Technical Service Bulletin

Subject: Solution Leakage

Models Affected:

AquaClean 18FLX, 56265001

Fig 1-

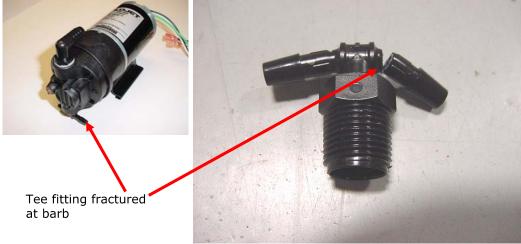
Issue: Solution leaking from under machine

Cause: Barb on Tee fitting 56507993 can be cracked or fractured if fitting is installed using barbs as

a handle or if spray hose is incorrectly oriented.

On machines with SN's between 2020917 – 2053323 where leakage occurs replace tee fitting with new nylon tee fitting or replace with adapter fitting 56264382, 90 deg brass street elbow 56396632 & 90 deg brass barb fitting 56470138 as shown in Fig's 2-5.

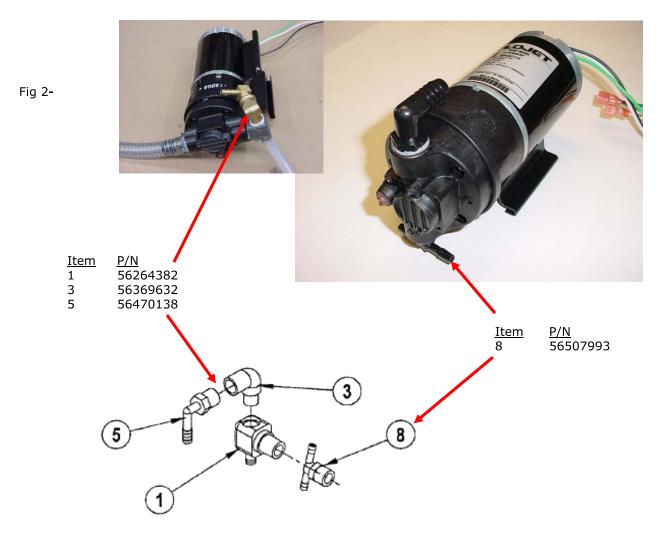
Note: Effective w/SN 2020917 Items 1, 3 & 5 were replaced with item 8 on the 18FLX

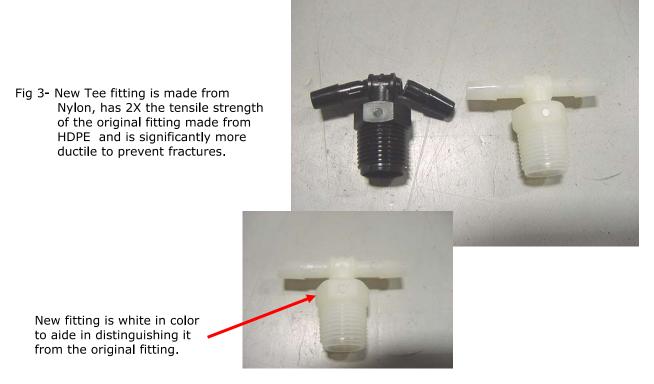
Spray hose orientation if brass fitting used as shown in Fig 2.

Spray hose orientation if plastic T fitting used.

Fig 5-

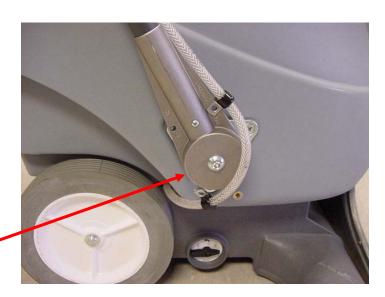
Spray hose routed out side of machine and fastened to handle.
